<b>BW Project No.:</b>	24-12-247
<b>BW Project Title:</b>	DPW. 25269 UI Campus Drive Repairs, Phase 3
<b>Client:</b>	University of Idaho
<b>Date:</b>	04-23-2026
<b>Addendum #:</b>	002

This addendum consists of a total of 4 pages and 16 drawings.

# UI: CAMPUS DRIVE REPAIRS, PHASE 3 UNIVERSITY OF IDAHO

10 STANDARD BENCH DETAIL - FRONT ELEVATION

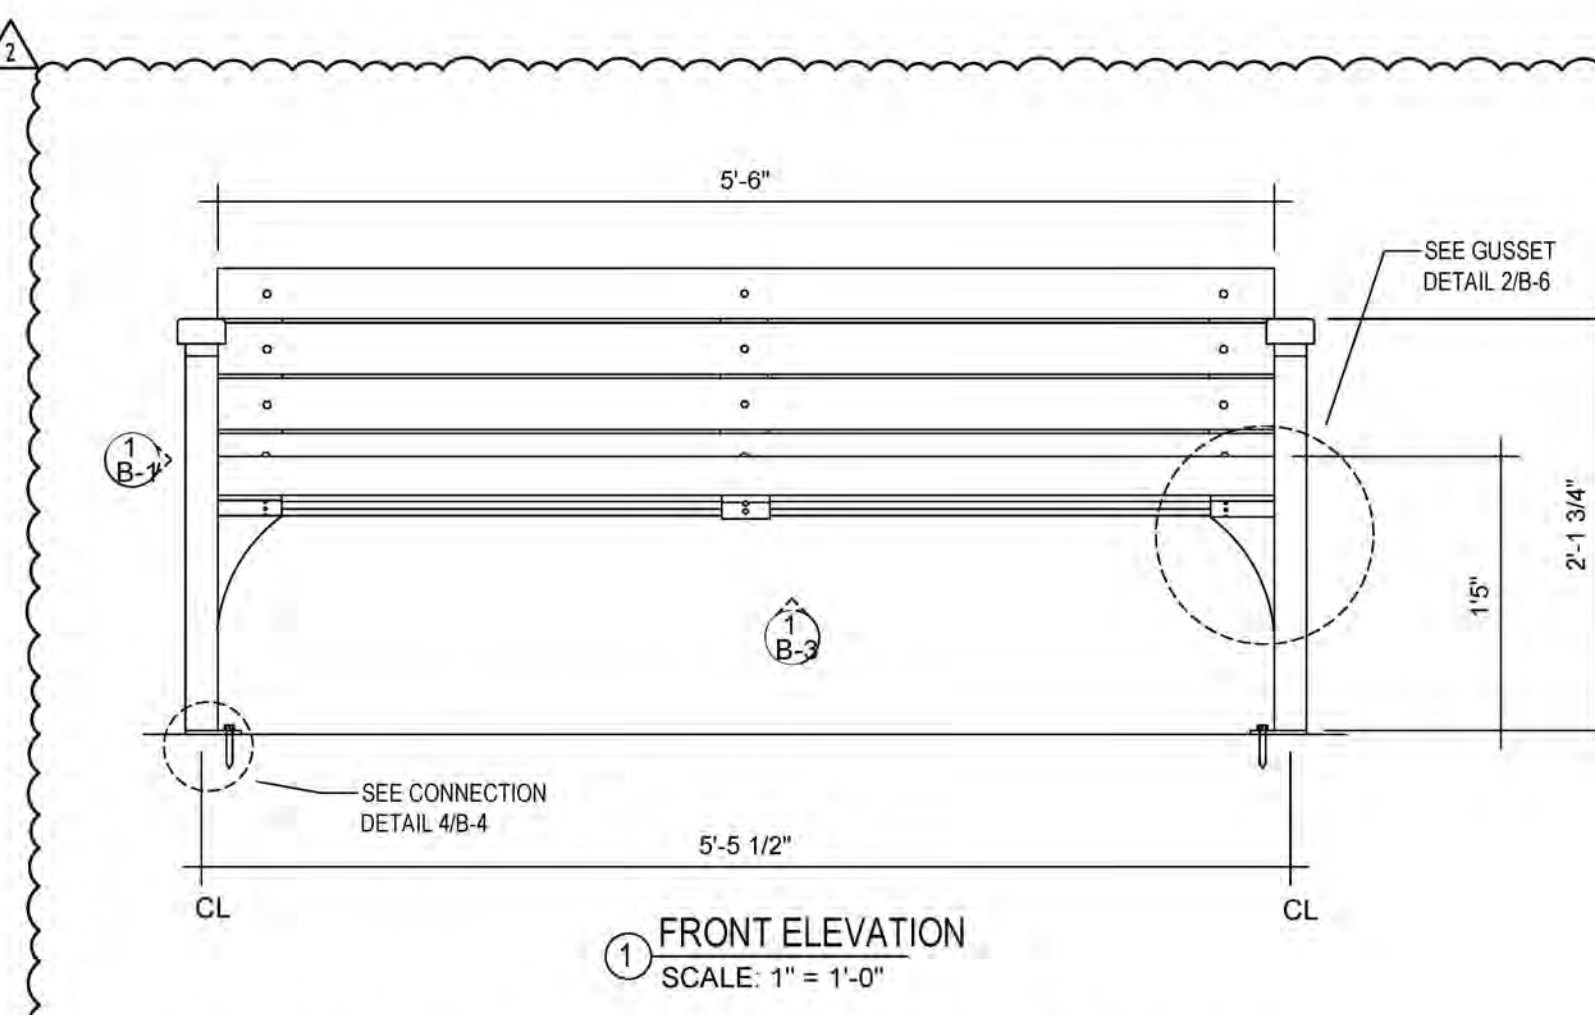
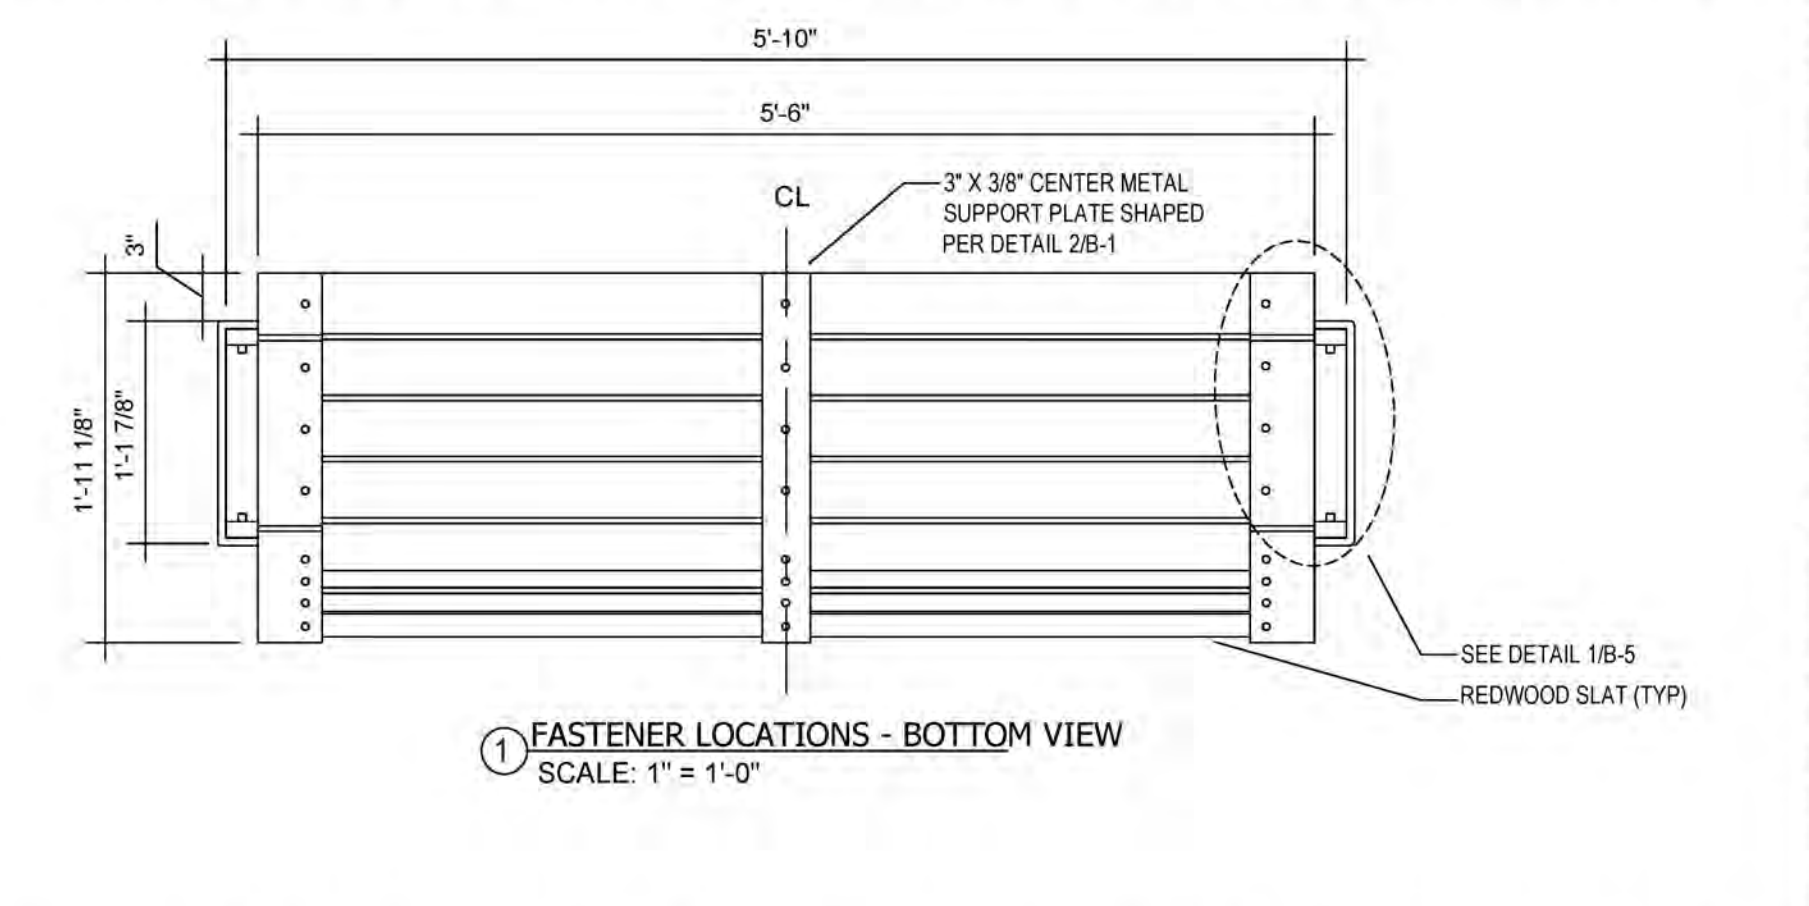
7. Sheet L3.2: Valve schedule information updated per revised nozzle design
8. Sheet L4.1: The following details were added to the set: 10 "STANDARD BENCH DETAIL - FRONT ELEVATION" and 11 "STANDARD BENCH DETAIL - FASTENER LOCATIONS - BOTTOM VIEW"

**TUNNEL ABANDONMENT /REMOVAL DETAILS**

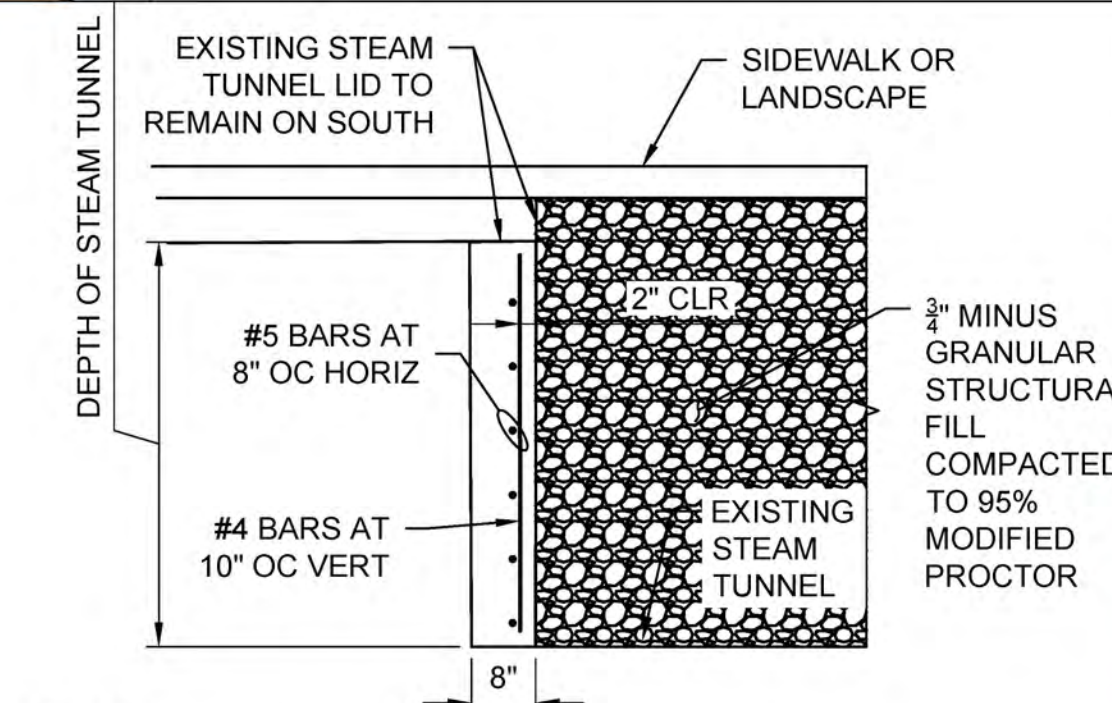
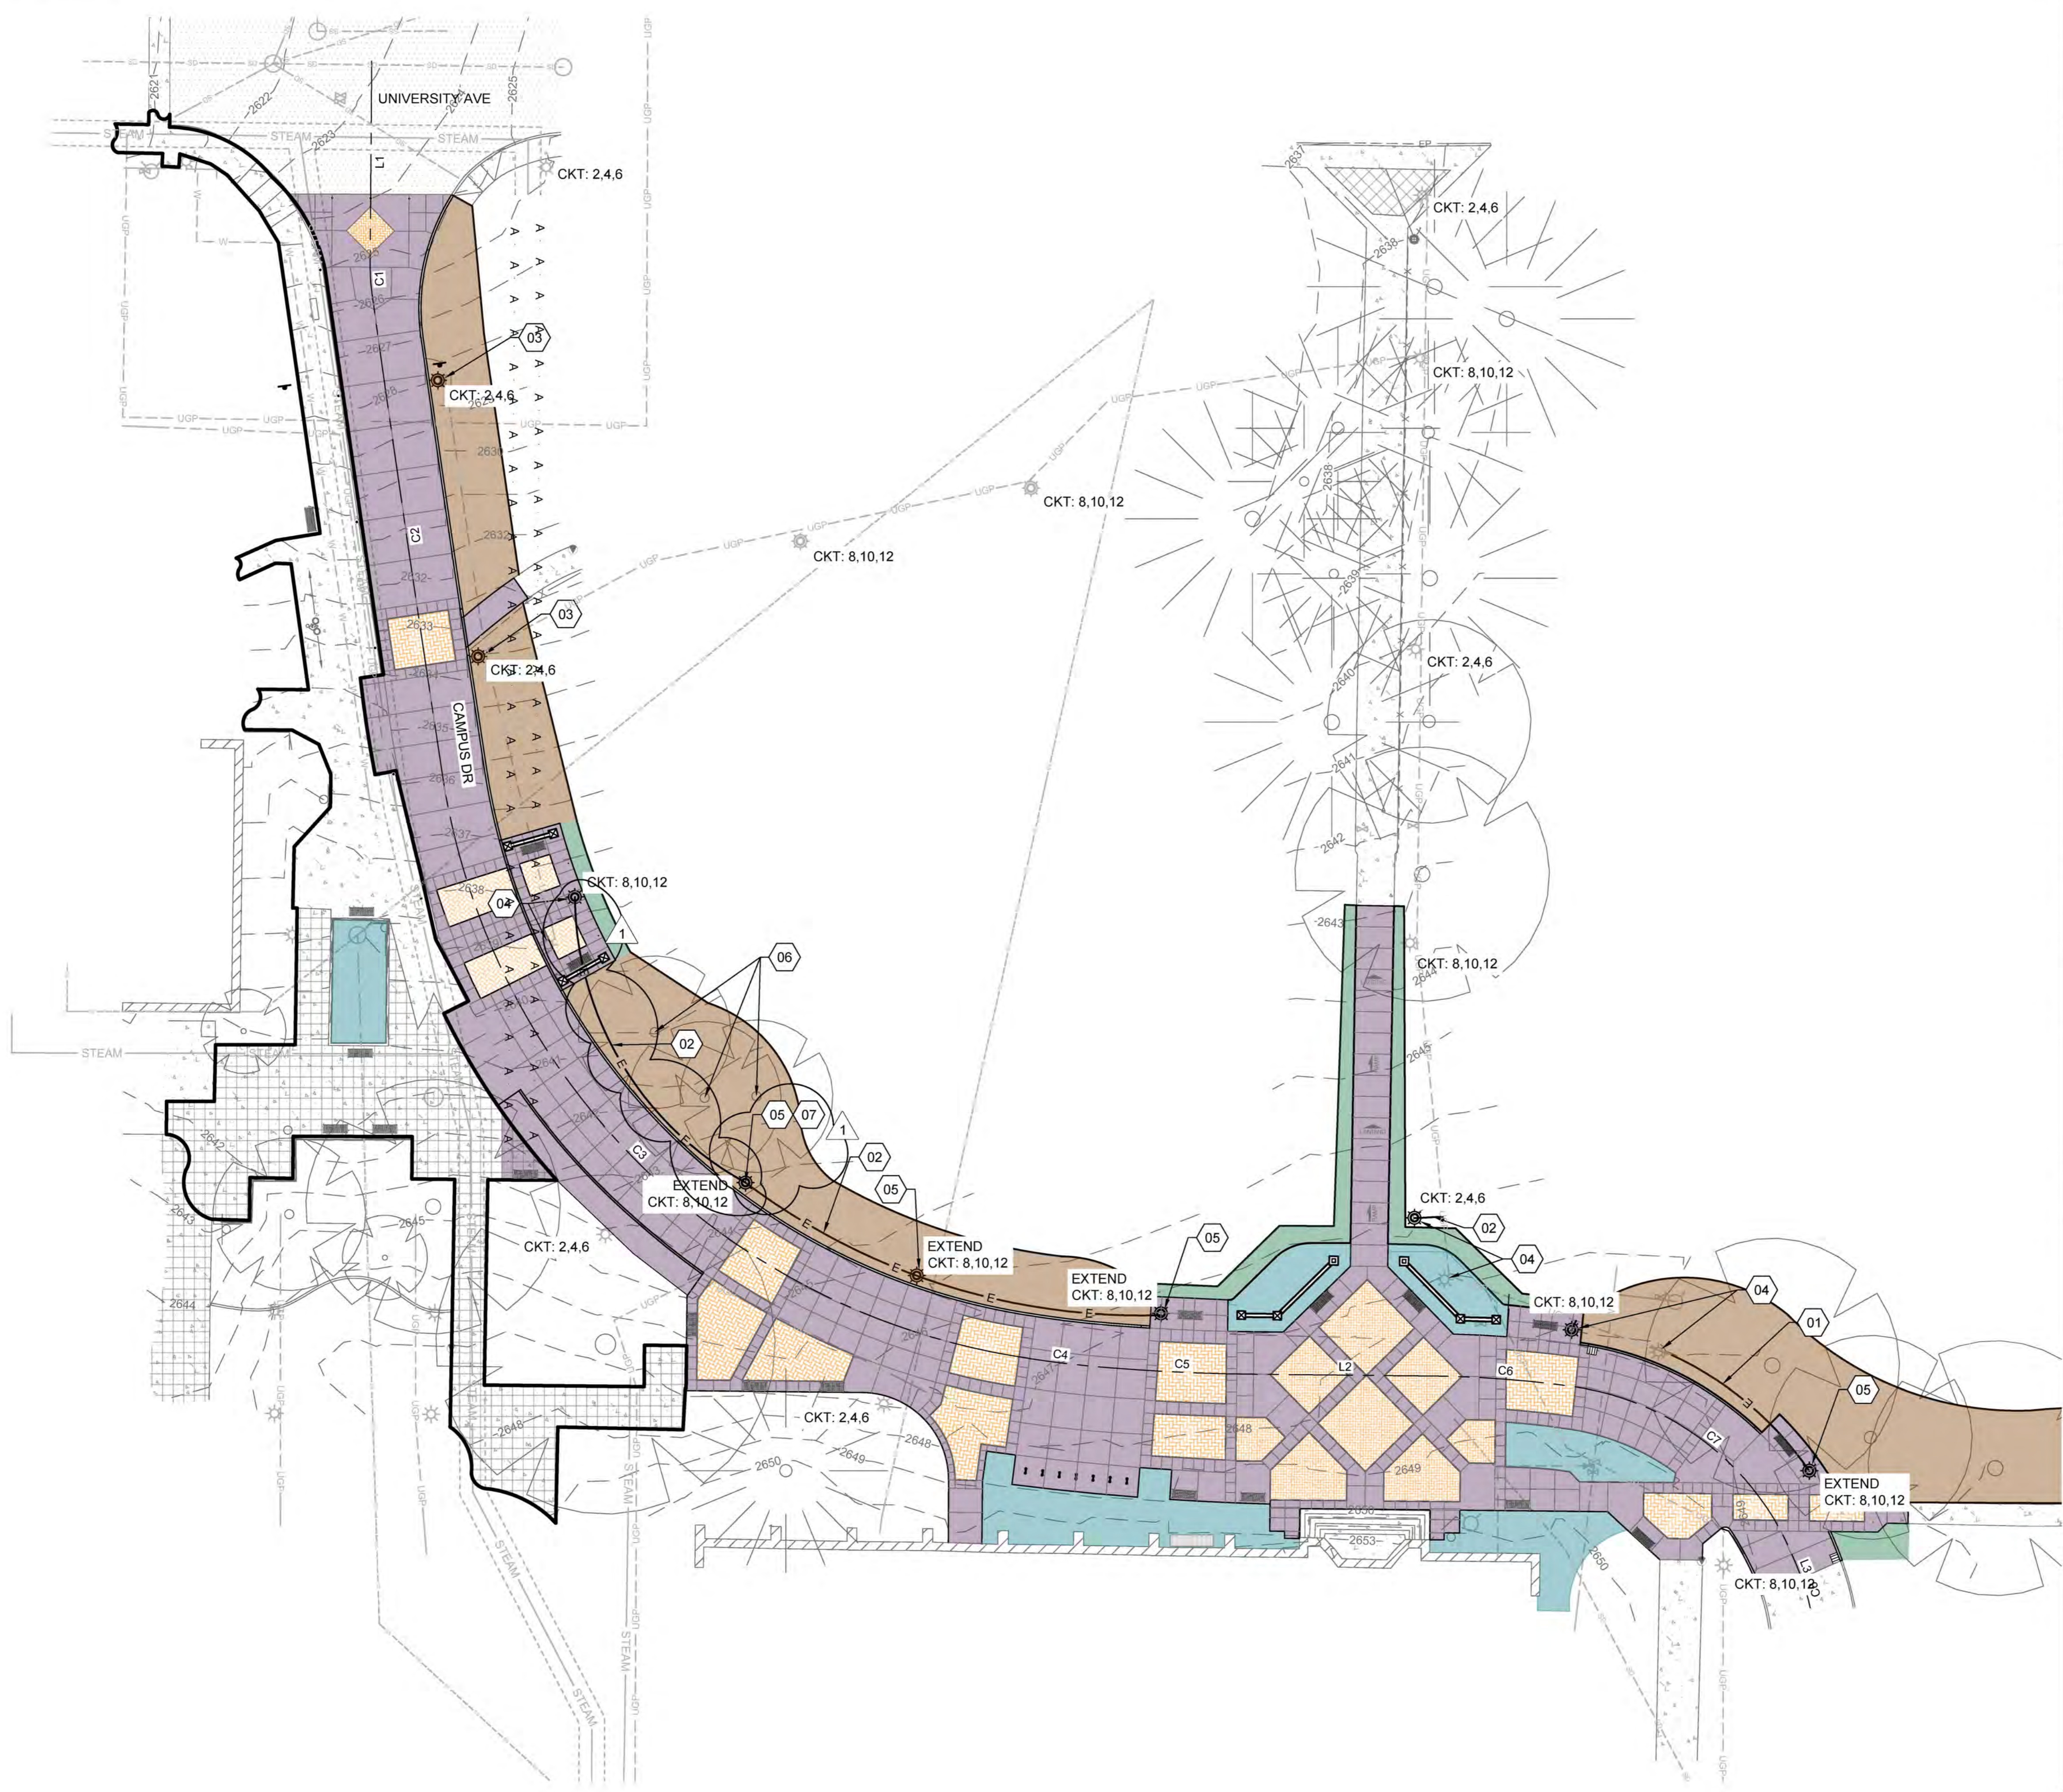
6. Question, *Is it the intent to remove the tunnel and backfill it and cut and cap utilities that are in conflict?*  
Answer: Contractor shall excavate and remove tunnel lid and walls, remove interior piping (multiple sizes and pipes), cap/plug ends, install concrete wall at removal limits on south, and backfill with 3/4" granular compacted structural fill. See Fig 1 for details.

- COMPRESSIVE STRENGTH OF EXISTING STEAM TUNNEL TESTED AT ≈1,000 PSI. REMOVE TOP AND WALLS OF TUNNEL TO SOUTHERN EDGE OF EXISTING ROADWAY AND BACKFILL WITH 3/4" CRUSHED BASE COURSE AGGREGATE AS APPROPRIATE. NOTIFY ENGINEER OF ANY CONCERNS.
- EXISTING COLLAPSED TUNNEL TO BE REMOVED. LID AND WALLS TO BE REMOVED TO SOUTHERN EDGE OF ROADWAY.
- EXISTING COLLAPSED TUNNEL TO REMAIN
- EXISTING NON-COLLAPSED TUNNEL TO REMAIN
- PLACE BARRICADE ALONG EXISTING CURB LINE IN FRONT OF REMOVED TUNNEL DURING CONSTRUCTION
- CONCRETE REPLACEMENT AREA. MATCH SCORING PATTERN AND REPLACE TO NEAREST SCORE LINE
